Missouri Clean Water Commission  
Capitol Plaza Hotel and Convention Center  
415 W. McCarty Street  
Jefferson City, Missouri 65109

November 7, 2012

**Water Quality Certification for the Jameson Island Shallow Water Habitat Project**

### Jameson Island Recommended Alternative 4

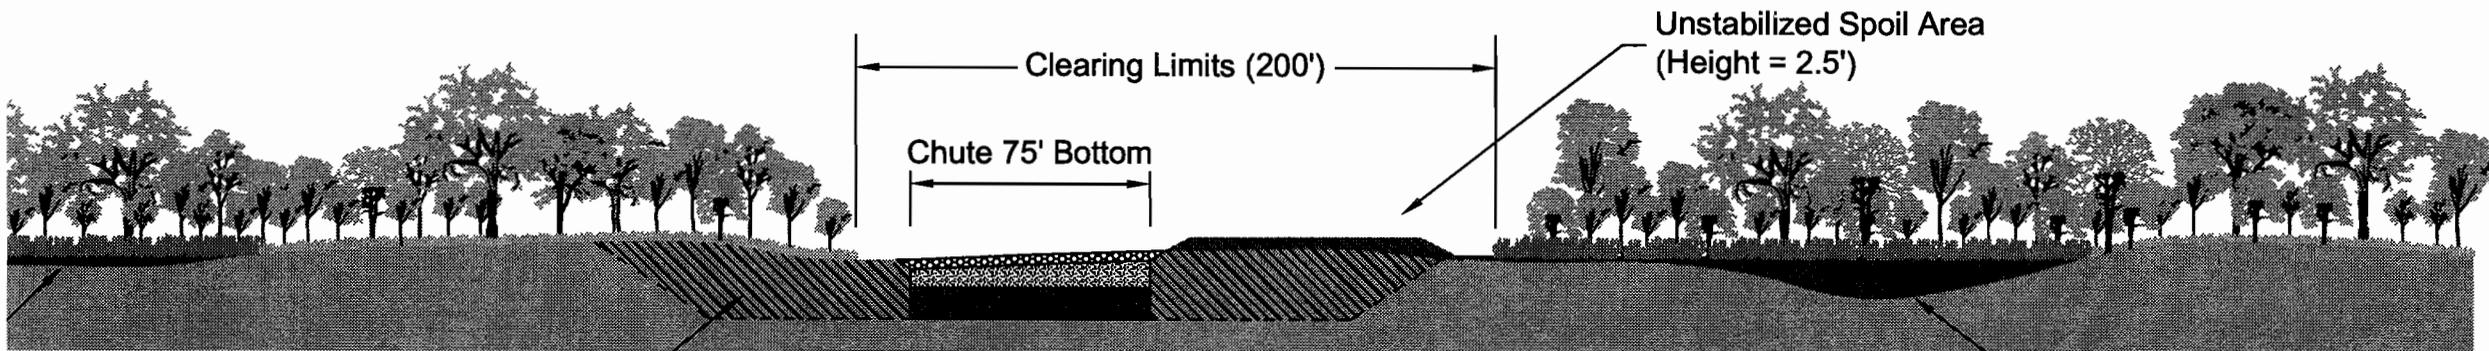
For clarity, I have attached renderings of the Recommended Plan Alternative 4, the potential modification to mechanically excavate the top three (3) feet of material (analyzed in my previous letter dated August 15, 2012), and the potential modification to mechanically excavate down to the ordinary high water mark.

### Jameson Island Potential Modifications

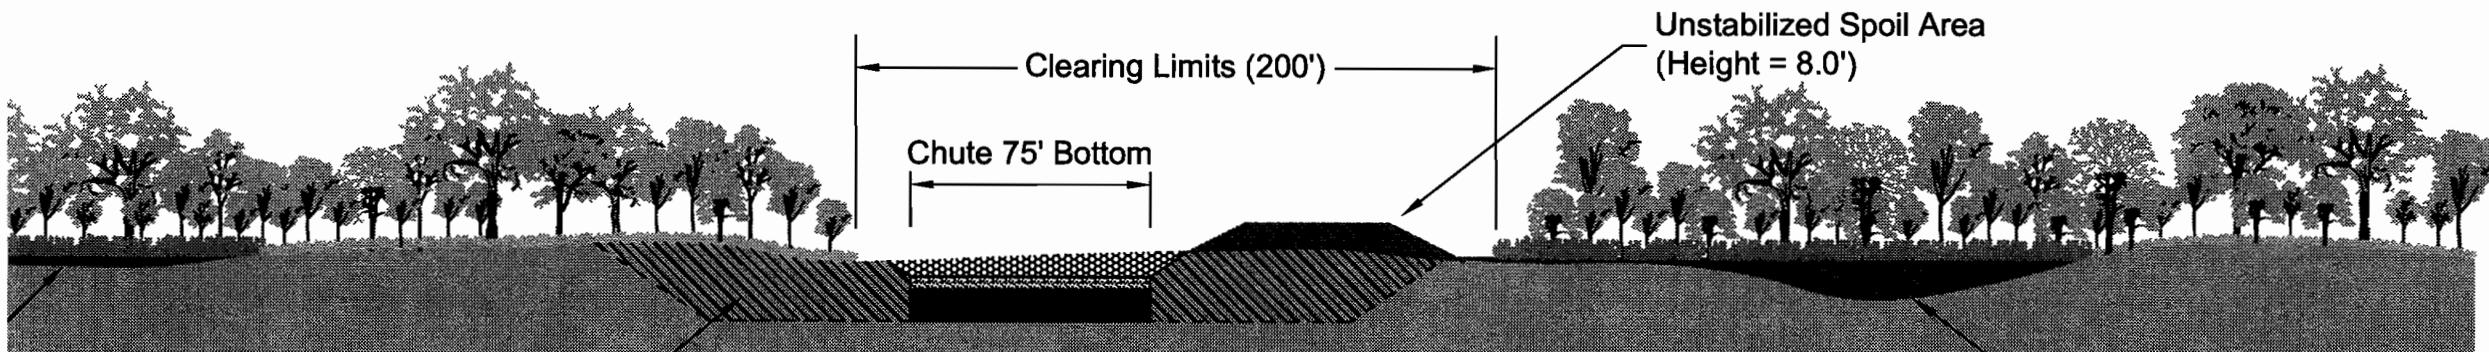
To remain consistent with the DRAFT 404(b)(1) evaluation, the analysis of this modification included the same construction footprint as Alternative 4 of the PIR. Two additional modifications would be necessary to maintain that footprint. The modifications include reducing the width of the pilot channel to seventy-five (75) feet wide, and combining the two spoil areas on each side of the chute, as proposed in the PIR, into one spoil area on the outside bend of the chute. The modifications were necessary to limit the height of the spoil piles and to fit the cross section of the pilot channel and the spoil area fit within the two hundred (200) foot wide clearing limits of Alternative 4.

For the Jameson Island project, the average elevation for the ordinary high water mark is approximately six (6) feet below the elevation of the existing ground surface. Some areas within the project limits are as high as ten (10) feet above the ordinary high water mark, and some low lying areas are already below the ordinary high water mark elevation. Given an average depth of excavation of six (6) feet and side slopes of 1:5 to 1, the top width of the pilot channel will total ninety-three feet. A twenty foot wide haul road was assumed for construction traffic. This left a width of eighty-seven feet for the spoil area. Given those constraints, the average dimensions of the spoil area will have an average height of nearly seven (7) feet and a top width of fifty-nine (59) feet with 2:1 side slopes.

The Corps has thoroughly analyzed the potential modifications that you have requested, and have identified four primary concerns with the potential modifications:

1. As a result of the temporary spoil piles, the benefits to the Howard County Levee District will be lower than that of Alternative 4 or the previous potential modifications analyzed by the Corps.

2. Our physical and biological monitoring of sites constructed with similar temporary spoil piles has shown that they do not develop the quantity or quality of habitat as quickly as other methods of construction.

3. The reduction in constructed chute width increases the chance the chute could be blocked by woody debris and deposition of fine sediments. These risks are slight and dependant on sequence of future flow events. In the event that a blockage of the chute would occur, additional construction to remove debris or to clear sediment plugs may need to be implemented.

4. The cost to the taxpayer is almost \$300,000 higher than the previous potential modifications analyzed by the Corps without achieving any greater environmental benefit, or any long term benefit to water quality.

The analysis performed by the Corps has determined that the potential modification of mechanically excavating down to the ordinary high water mark is feasible for the Jameson Island project. The concerns listed above support that the Recommended Plan Alternative 4 with the potential modification of mechanically excavating the top three (3) feet of material is a technically superior alternative to this option. The analysis did not support spending additional taxpayer resources for this modification as it provides no greater environmental or flood risk management benefits.
